UNITED STATES PATENT AND TRADEMARK OFFICE

APPLICATION NO.	FILING DATE	FIRST NAMED INVENTOR	ATTORNEY DOCKET NO.	CONFIRMATION NO.
09/828,470	04/06/2001	Richard W. Layne	41914.551 / P0031752.01	6760
46333	7590	07/20/2009		
Medtronic Attn: Noreen C. Johnson, IP Legal Department 2600 Sofamor Danck Drive Memphis, TN 38132			EXAMINER NGUYEN, CAMTU TRAN	
			ART UNIT	PAPER NUMBER
			3772	
			MAIL DATE	DELIVERY MODE
			07/20/2009	PAPER

Office Action Summary

DETAILED ACTION

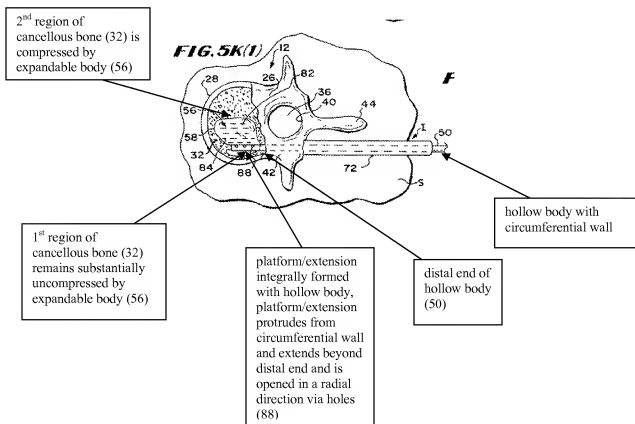
With regards the extension protruding from the circumferential wall and beyond the distal end, according to applicant's the specification on page 15 lines 6-7, the extension is the platform, structurally. In addition, the specification on page 15 lines 16-17 discloses the platform (220)

could be formed integrally with the hollow member (210), thus, for purposes of broad interpretation of the latter disclosure, it is reasonable for one skilled in the art to interpret the Reiley's Figure 5k(1) is consistent with applicant's specification. Furthermore, applicant's Figure 2, tool (200) comprising a distal end (250), an extension/platform (220) protrudes from tool's (200) wall and beyond the distal end (250). Applicant's Figure 2 illustrates the distal end (250) is closer to the tool's (200) proximal end than the extension/platform (220). See illustration below.

Figure 5K(1) illustrates the catheter (50) introduced into the interior volume (30) occupied in the cancellous bone (32) and the expandable body (56) expanding on one side of the distal end of the catheter (50).

Figure 5K(1) illustrates the platform/extension induce the expandable body (56) from expanding in more than one direction and expanding from the distal end towards the platform/extension. Figure 7 illustrates the injector tip (90) occupying in cavity (84) while the expandable body (56) collapses and the injector tip (90) injects filler material into the cavity (84).

With regards to the 1st step in claim 1 reciting the **platform that is open in a radial direction and has a side surface facing in the radial direction**, Figure 5K(1) illustrates the platform is open in a radial direction and that it has a side surface facing in the radial direction via holes (88).

With regards to claim 24, Figure 5K(l) of the Reiley et al illustrates the extension/platform (see illustration above) extends beyond the catheter tube (50) from only a circumferential portion of the catheter tube's (50) circumferential wall, particularly when the extension/platform extends at central point of hole (88), thereby, rendering the extension/platform extending from only a circumferential portion of the catheter tube's (50) circumferential wall and not the entire circumferential wall.

Clearly, the illustration of Reiley et al's Figure 5K(l) interpreted above discloses applicant's invention.
